# SERVICE INSTRUCTIONS

Model 100  
Service Bulletin S1

## SERVICE INFORMATION FOR MODEL 100 INTRAVANCE® TIMING DEVICES

**LOW IDLE SCREW CAPSULE ASSEMBLY KT 85226****PRODUCT AFFECTED:**

**FIGURE 1. KT85226-1****FIGURE 2. KT85226**

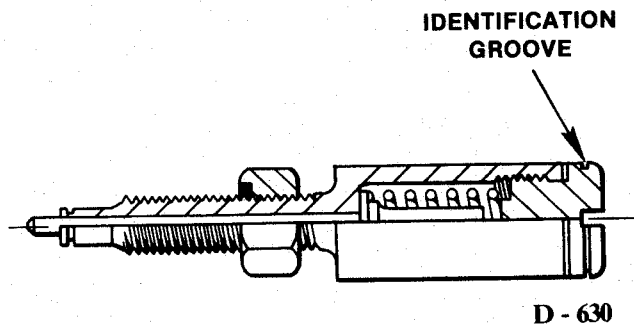
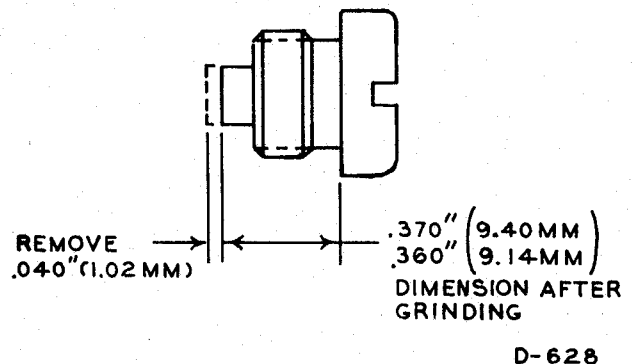
Reports have been received indicating an inability to achieve low idle shut-off on certain M-100 pumps equipped with low idle screw capsules (KT 85226). This condition can be corrected by either modifying the existing assembly or by replacing the assembly with KT 85226-1. The new low idle screw capsule allows increased piston travel in order to achieve engine shutdown. This assembly can be identified by a groove around the O.D. of the capsule screw plug. (Refer to Figure 1).

Modification of the **existing** low idle screw capsule (KT 85226) can be done as follows:

- (1) Remove retaining ring from end of screw (inside governor).

- (2) Remove low idle screw capsule and clamp in a soft-jawed vise with screw plug facing upward.
- (3) Use an impact tool to loosen and remove screw plug from the assembly.
- (4) Grind .040" from screw plug (end opposite screw head) as indicated in Fig. 2, below.
- (5) Reinstall screw plug using a new copper gasket (GA 7965) between screw plug and capsule body.
- (6) Torque screw plug to 15 - 20 lb. ft. (20 - 27 Nm).
- (7) Reinstall low idle screw capsule assy. using a new "O" ring (GA 1074) and torque retaining nut to 50 - 60 lbs. in. (5.5 - 7.0 Nm).
- (8) Install retaining ring in groove at end of capsule screw. Retaining ring installation tools (Waldes EX 0214, or equivalent) are available from tool manufacturers and will assist in ring installation.
